TECHNICAL BULLETIN
Bell Helicopter

No. 205-08-122

MODEL AFFECTED: 205A/205A-1

SUBJECT: TAILBOOM ASSEMBLIES P/N 205-032-802-003 THROUGH -051 & 212-030-100-081 THROUGH -107, MODIFICATION FOR USE ON ALL MODEL 205A/A-1 HELICOPTERS

Figure 1
General View

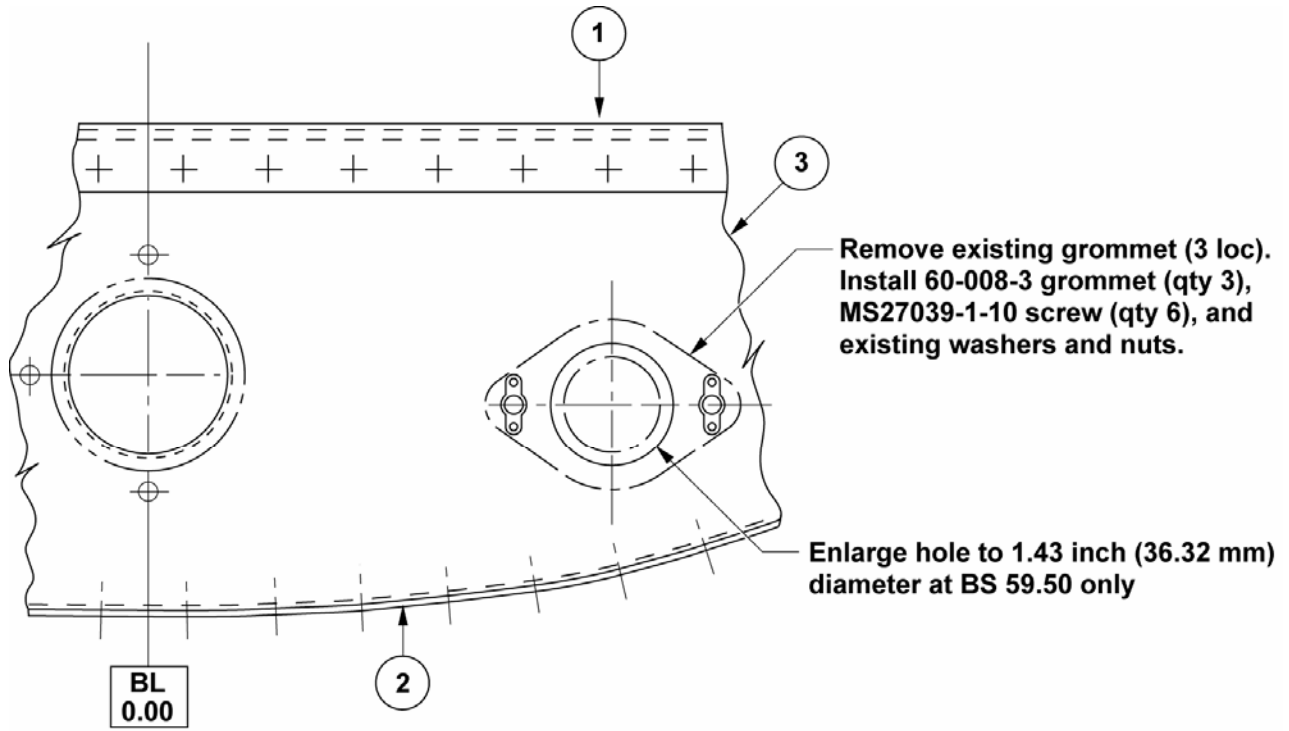
- h. Re-install elevator control tube.
- 3. This paragraph describes a modification to upgrade the Center Tailboom Section as well as some modifications to the vertical fin. Refer to Figure 1, 3, 4 & 5. Deburr all holes prior to final installation.
 - a. Install tailboom in an approved fixture.
 - b. Remove side skins and lower skin between BS 101.38 and 194.30 recording type, size and location of fasteners.
 - c. Remove all four longerons between BS 101.38 and 175.00 and splices at BS 175.00 recording type, size and location of fasteners.
 - d. Remove bulkheads at BS 122.23, 143.28 and 164.23 recording type, size and location of fasteners.
 - e. Using top skin rivet holes as locators, position and install new bulkheads as follows using original type and size fasteners:

Figure 2
Bulkhead (BS 59.50) Upgrade
(View Looking forward)

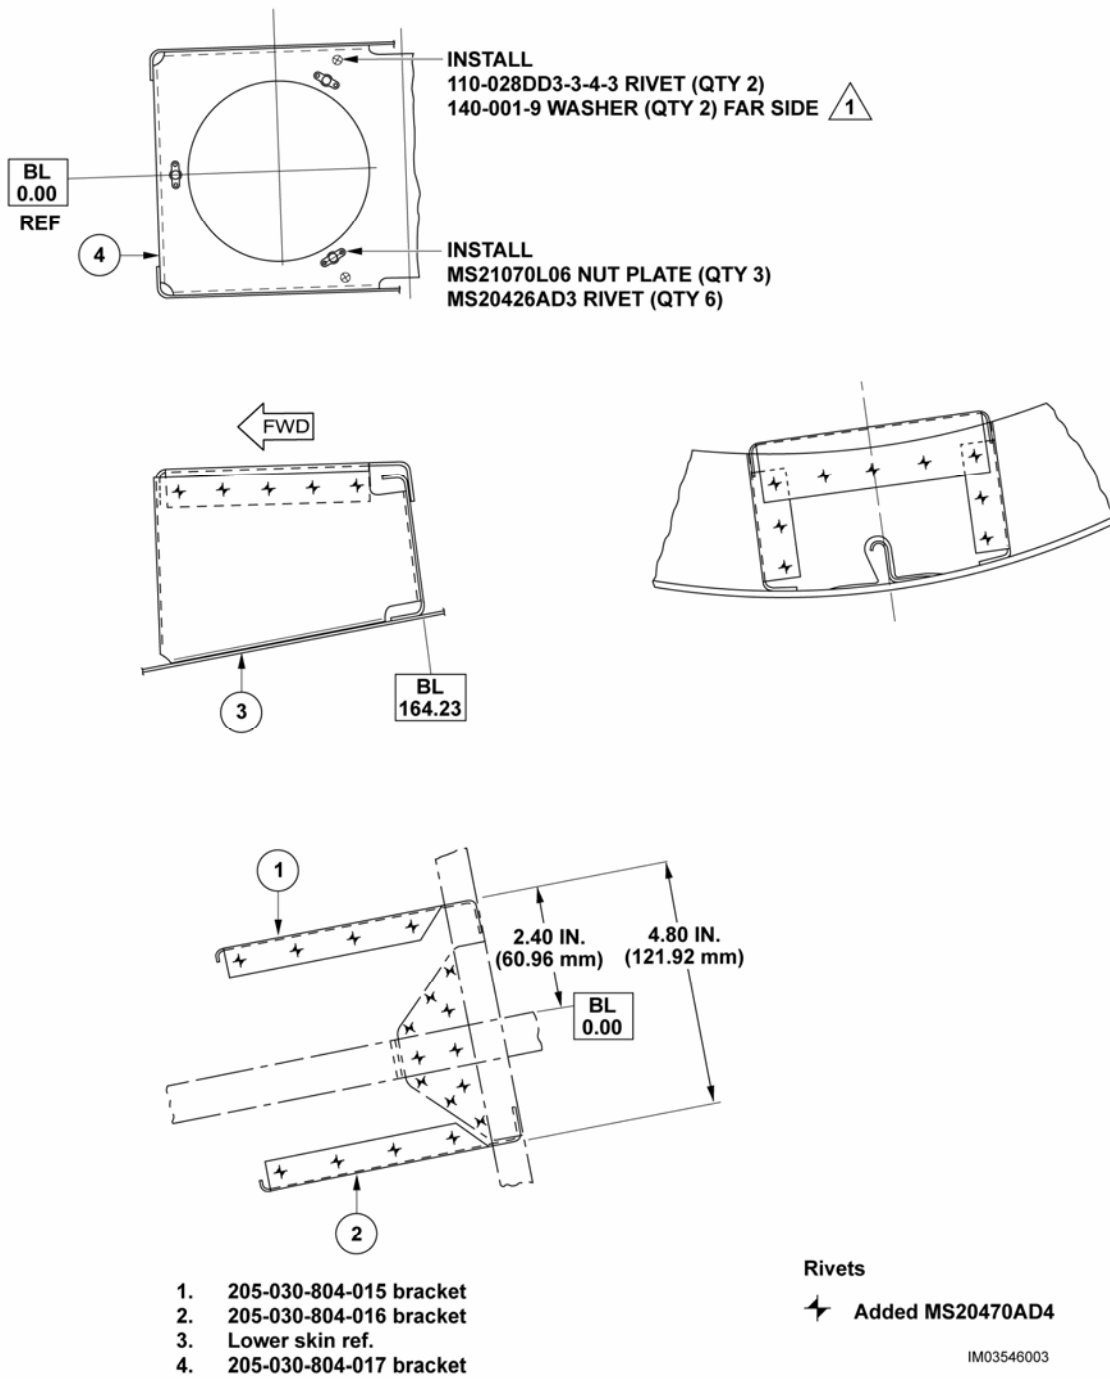
2. This paragraph describes a modification to upgrade Bulkhead (BS. 59.50) by increasing the size of one hole for the elevator control tube and replacing (qty 3) fairleads, as follows (refer to Figure 1 & 2):

- a. Remove elevator control tube P/N 205-001-038-001 or -101.
- b. Remove lower panel P/N 205-032-814-003 recording type, size and location of fasteners.
- c. Remove three fairleads at BS 37.65, 59.50 & 80.56.
- d. On frame P/N 205-032-817-017 at BS 59.50, mark and enlarge hole to 1.43-inch diameter, as shown on Figure 2.
- e. Deburr and apply primer to any bare metal area.
- f. Install three new grommets P/N 60-008-3 using six MS27039-1-10 screws and existing washers and nuts.
- g. Apply sealant (C-308) to faying surfaces and re-install lower panel. Apply a bead of sealant around periphery of panel.

Figure 3
Flux Valve Bracket Installation

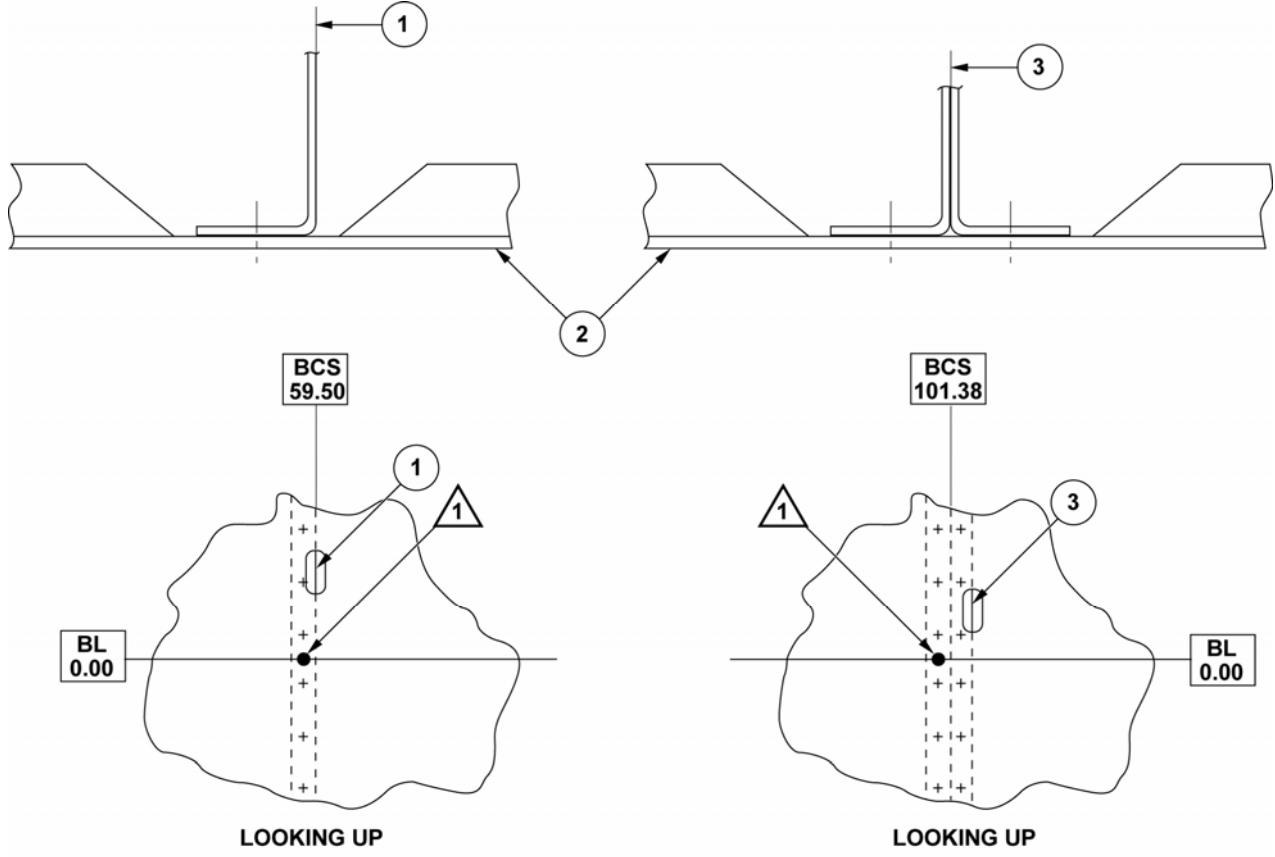
- j. Build-up and install flux valve support bracket at BS 164.23 as shown on Figure 3.

$\triangle 1$ It is permissible to trim 0.06 inch (1.52 mm) maximum to cover bracket radius.

Figure 5
Doubler Installation

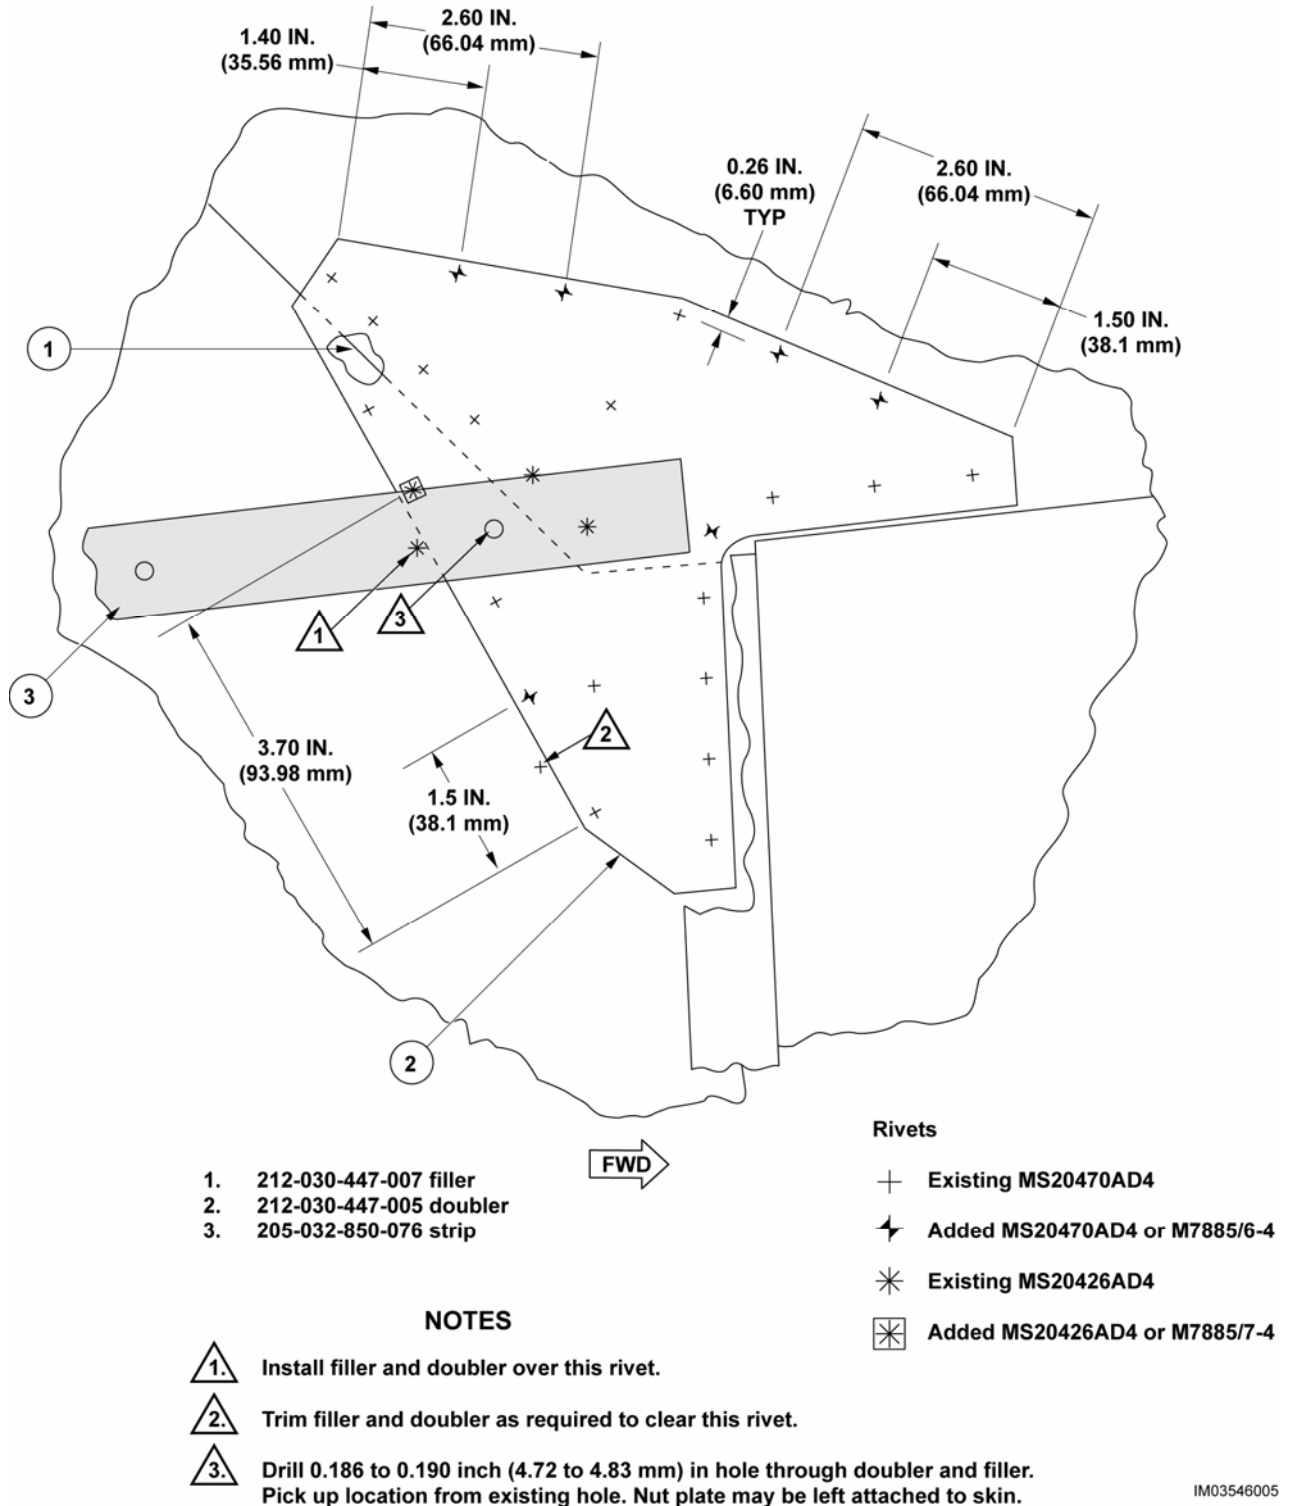
- m. Remove original strip 205-032-850-076 from RH side of fin. Remove rivets at base of vertical fin (RH-side, forward skin) enough for the installation of doubler and filler, as shown on Figure 5, recording type, size and location of fasteners.

- o. Clean all cavities of fin from rivet stems and other foreign objects and install doubler and filler using original type and size fasteners as shown on Figure 5.

- n. Mark and drill doubler and filler 212-030-443-005 and -007 and deburr.

Figure 6
Bulkhead (BS 101.38) Upgrade
(View Looking Aft)
Portion of drain tube removed for clarity

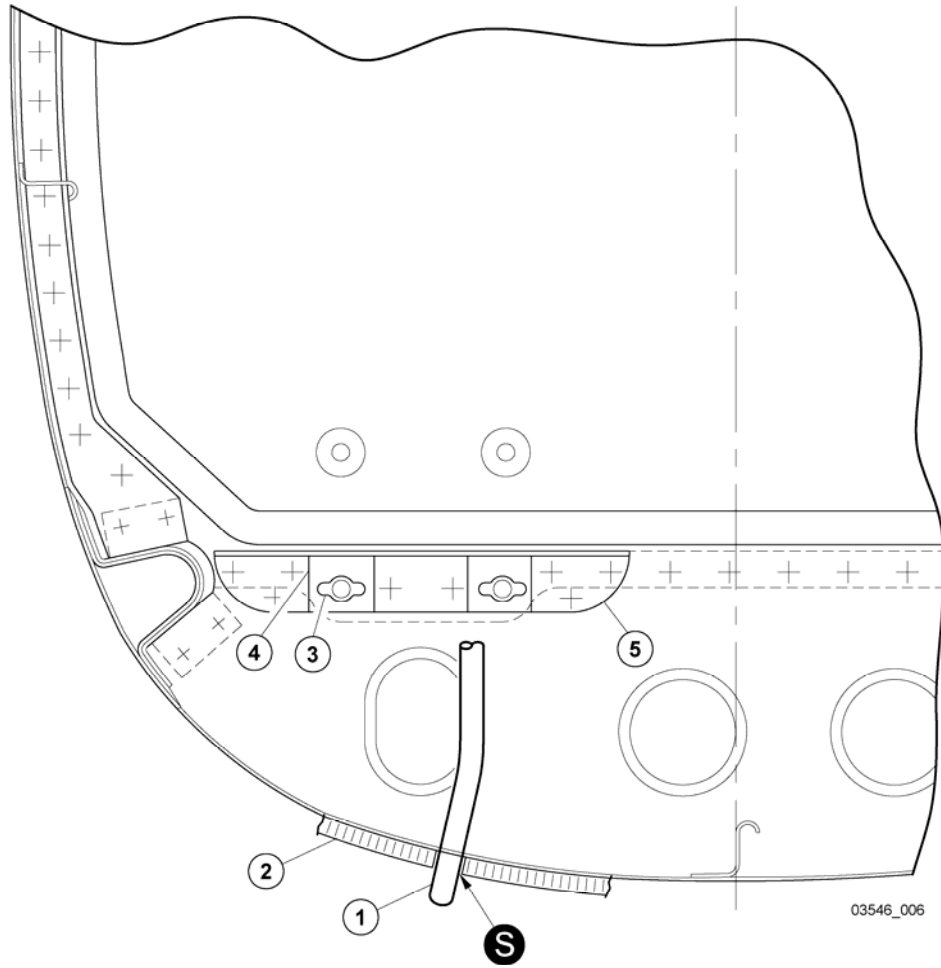
4. This paragraph describes a modification to upgrade Bulkhead (FS 101.38) by replacing an angle (P/N 205-032-805-027) made of aluminum with a stronger one (P/N 205-032-805-041) made of steel. Paragraph 2 should be accomplished concurrently with this paragraph (if required). Refer to Figure 1 & 6.

- a. Remove Bellcrank Support from aft face of Baggage Compartment Aft Bulkhead.

- b. Remove Drain Tube from lower surface of Baggage Compartment Floor recording type, size and location of fasteners.
 - c. Remove rivets holding Nutplates, Radius Blocks and Support.
 - d. Transfer rivet holes on new Support P/N 205-032-805-041. Temporarily secure with Cleco fasteners. Deburr holes.
 - e. Install Support, Radius Blocks and Nutplates using original type and size fasteners.
 - f. Reinstall Drain Tube using sealant (C-308) on upper flange and using existing type and size of fasteners. Apply Sealant (C-308) around tube at Panel assy, as shown on Figure 6.
 - g. Reinstall Bellcrank Support on aft face of Baggage Compartment Aft Bulkhead.
5. Using a vibrating stylus, mark tailboom mod plate with the new configuration part number with the suffix FM (e.g. 205-032-802-051FM), this technical bulletin number and the date of compliance.
